6th Avenue Mixed-Use

708 6th Avenue N, Seattle, WA 98109

Design Review Recommendation
DPD # 3009330
December 17, 2008

WALL SECTIONS

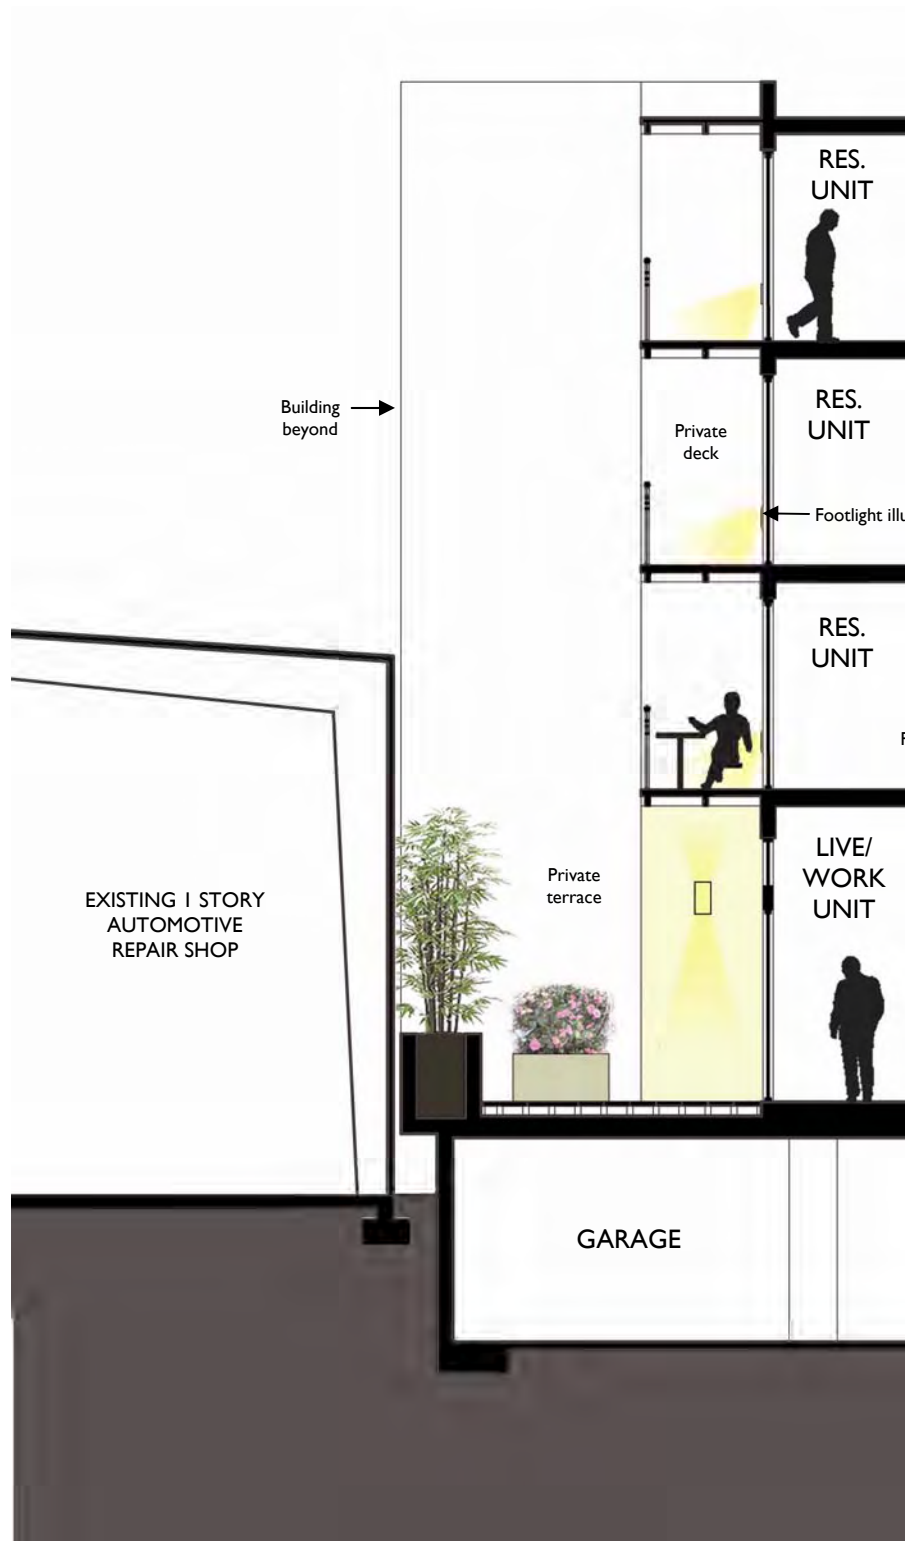
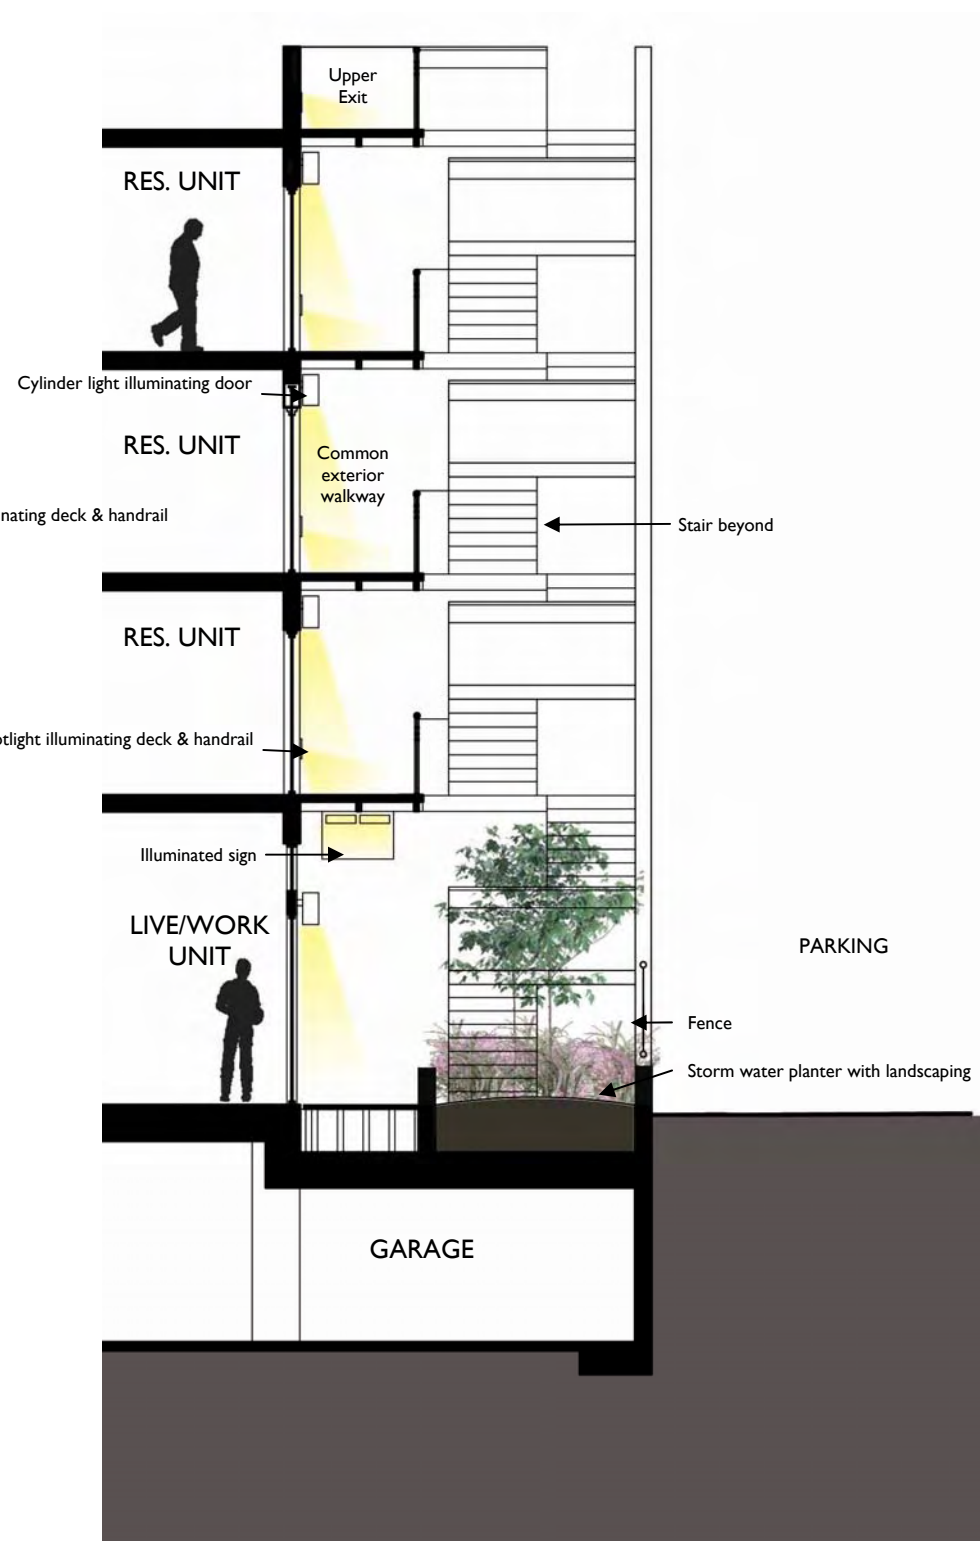
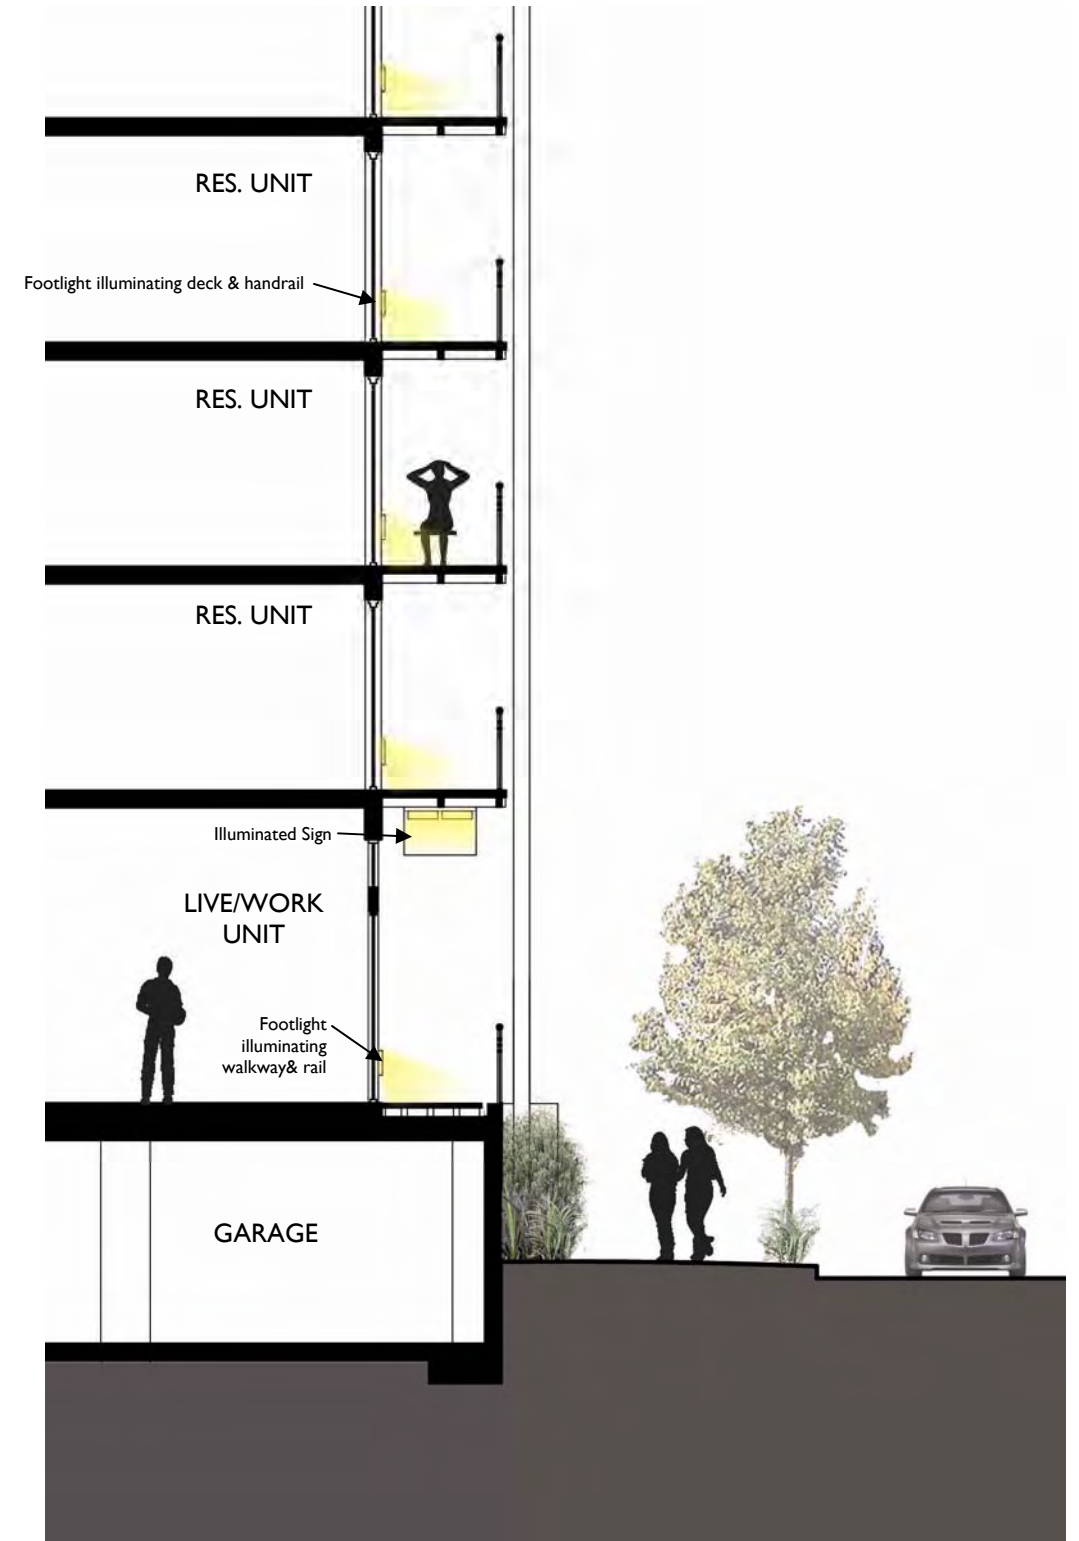
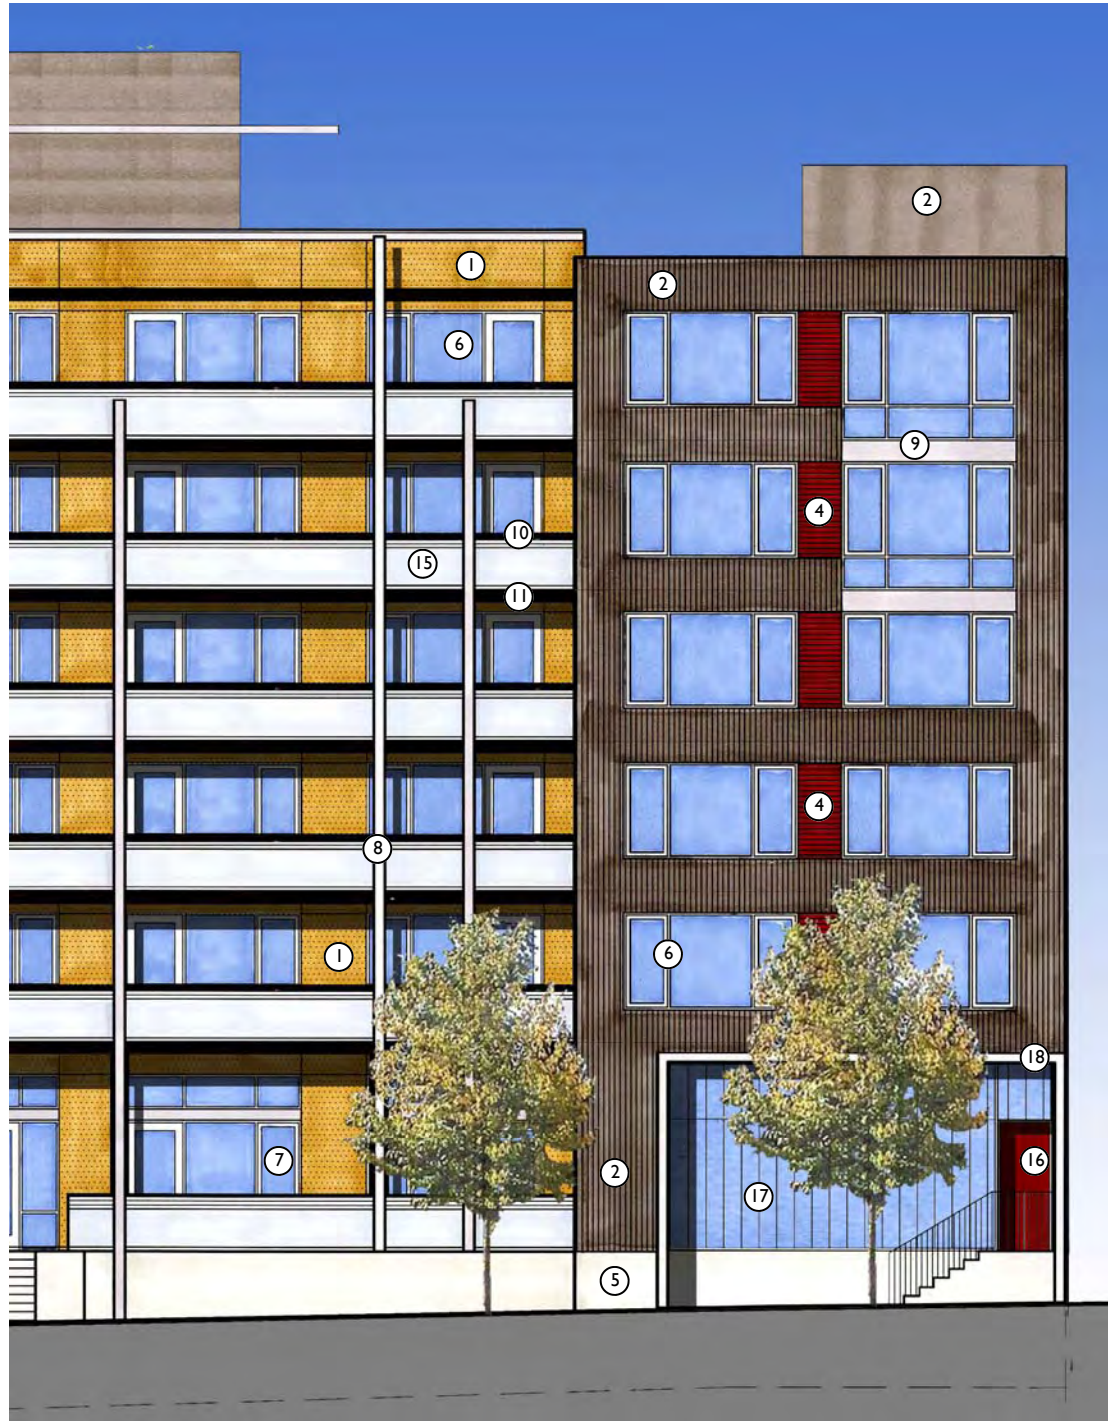
- The Board instructed the applicants to bring cross-sections that illustrate the balcony units and the live/work units on Aurora Avenue North and how they relate to the adjacent properties.

See the responses to A-1, A-3, C-3, D-1 and D-2 above for a description of the transition space between the residential entries and the sidewalks. This sense of transition is carried into the building through the use of exterior walkways, which experientially fall somewhere between public and private space. We will bring

cross sections as requested to the Design Review Board meeting. See A-5, B-1 and D-2 above for a response to the bullet point concerning blank walls and relationship to the adjacent properties. We will bring information on exterior signage and garage venting to the Design Review Board meeting. We have designed the retail space to function as a viable commercial retail space in the future when it is not longer being used as a leasing office.

ROOF LEVEL LANDSCAPE PLAN

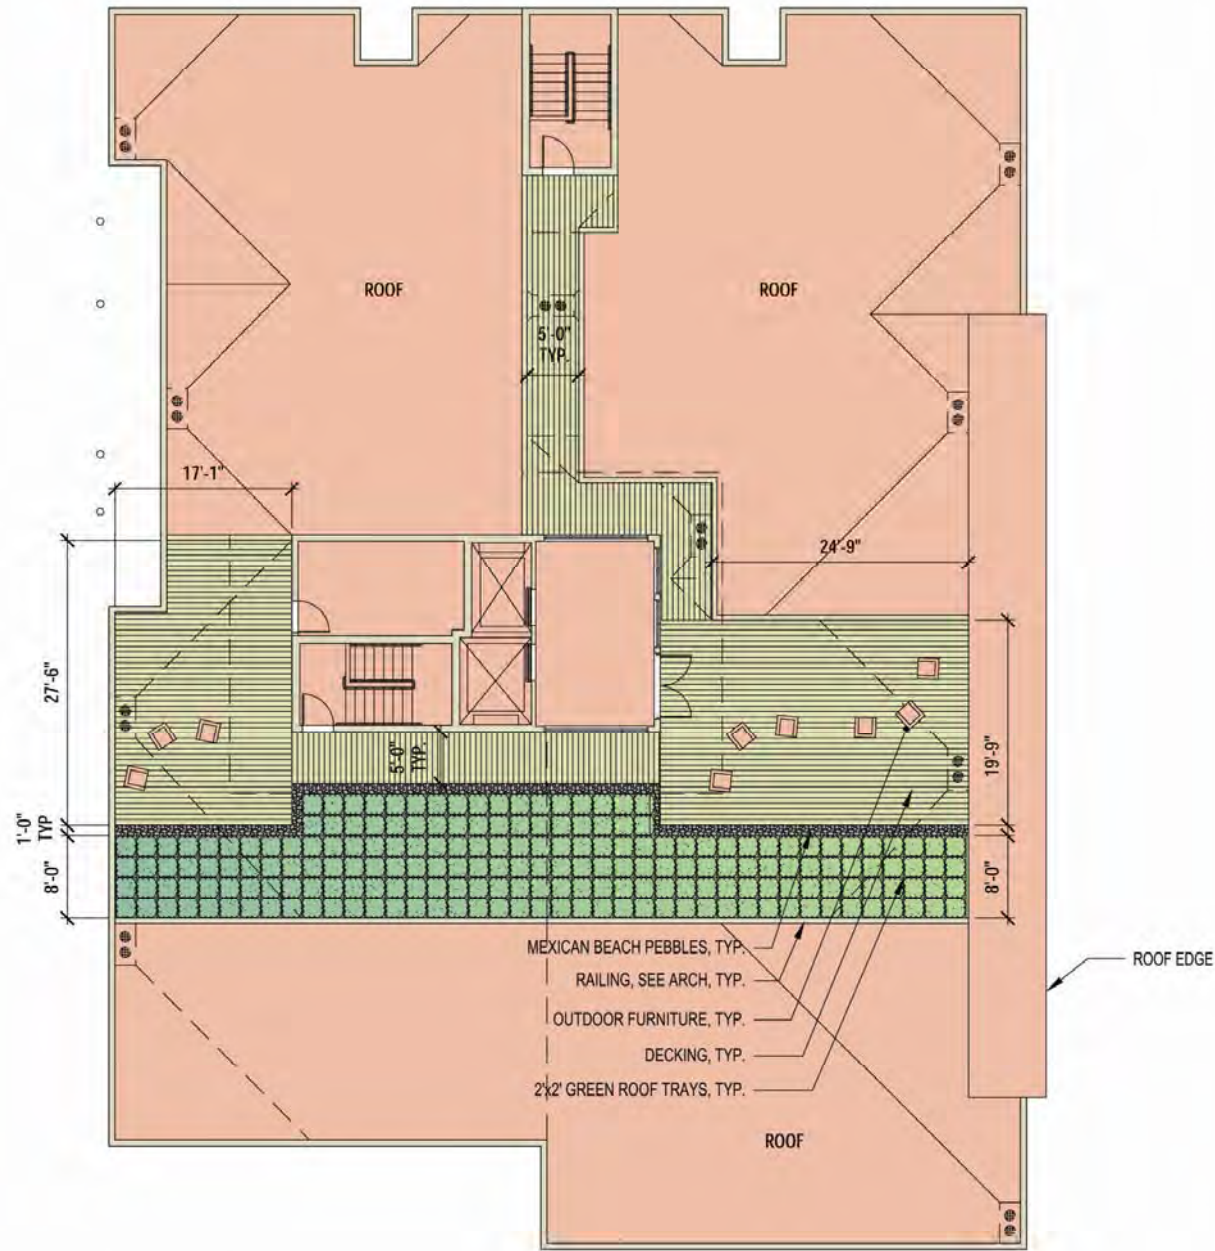
- The Board agreed that the Aurora Ave. N. environment is not very pedestrian friendly but would like to see landscaping along the building edge to soften the blank wall of the garage level.
- The board is looking forward to a detailed landscape design that addresses the Green Factor and special treatment for sidewalks, street trees and fencing.

See D-2 and D-5 above for a response concerning the landscape buffer at the Aurora Ave sidewalk. Complete landscape plans and green factor calcs are included in the MUP set, and we will bring colored landscape plans to the Design Review Meeting.
